A set of 53 questions was prepared by the NRC staff to support an audit of the AURORA-B loss-of-coolant accident (LOCA) methodology. These questions were initially discussed with AREVA during a teleconference on November 1, 2016. During the AURORA-B LOCA audit on May 16-18, 2017, AREVA provided draft responses to the majority of the questions. Based on a brief review during the audit, the NRC staff provided feedback on AREVA's draft responses. A summary of the technical interactions on each of the 53 issues is captured below.

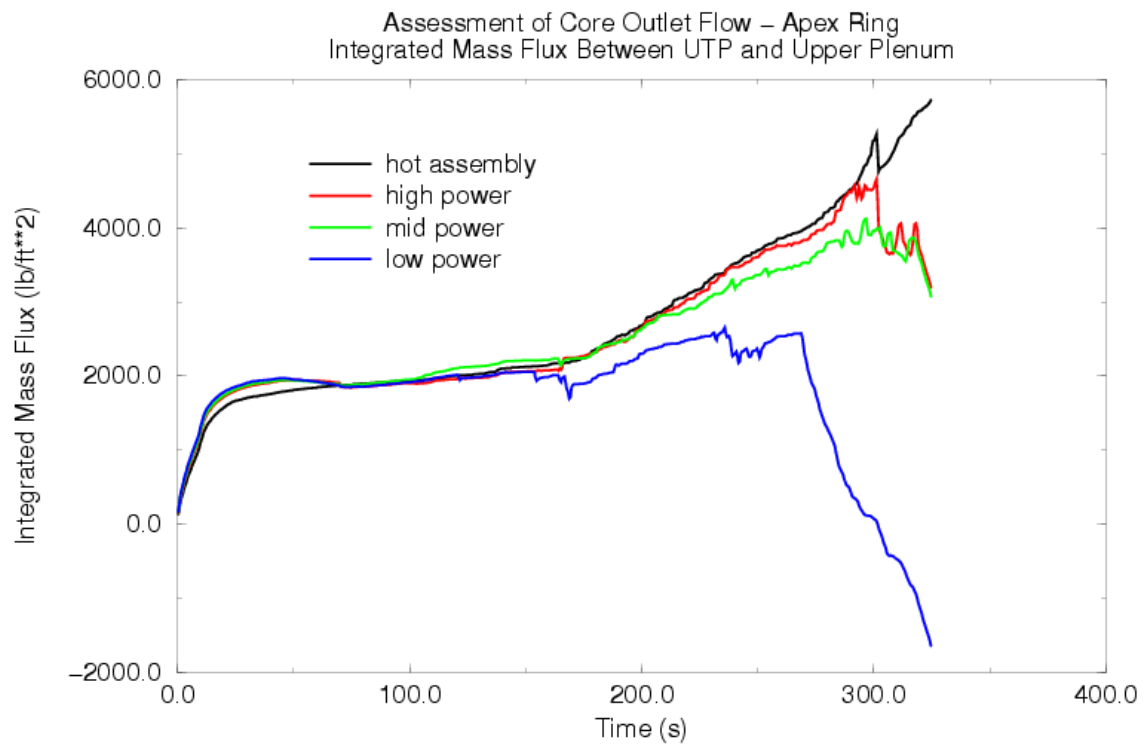
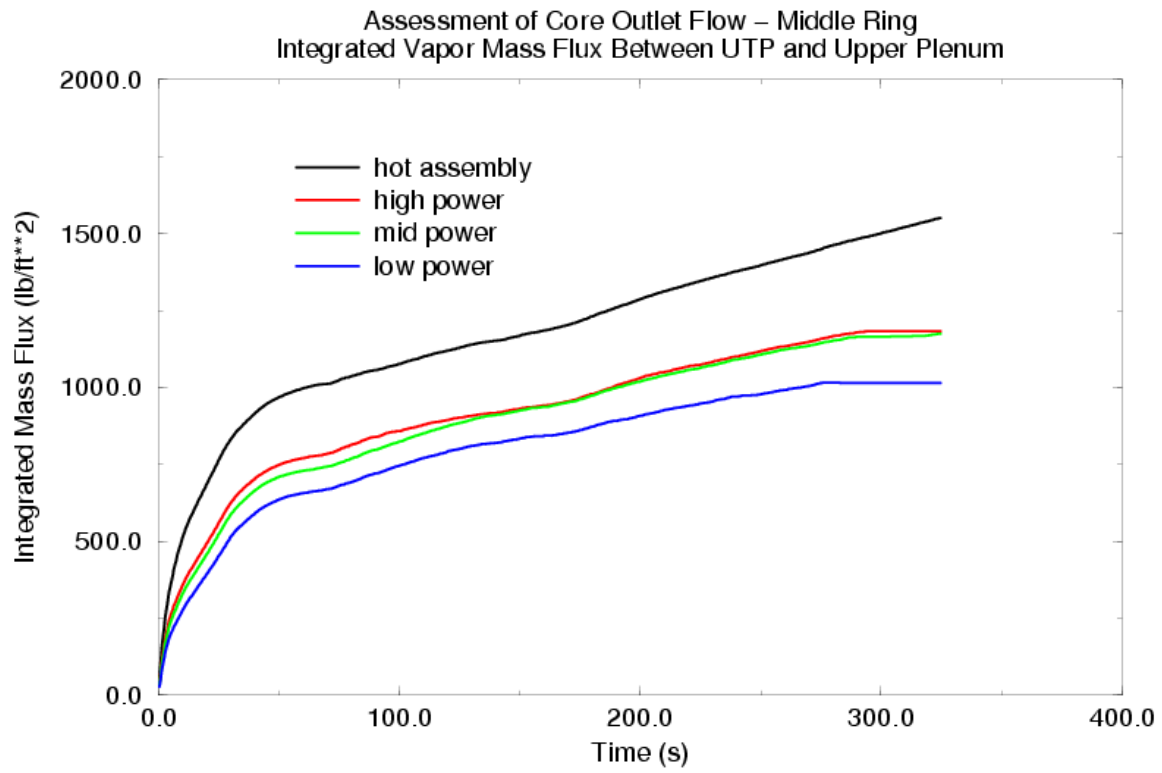
31. NRC staff seeks to understand which channels are in different flow modes for one or more demonstration cases.

Results from BWR/6 large break demonstration case from Section 7.7.6 (1.0 DEG, Pump Suction, SF-LPCS, mid-peaked) are plotted below showing the integrated mass fluxes at the exit of each core channel. [

]. The first three figures show the integrated total, liquid and vapor mass flux for the [
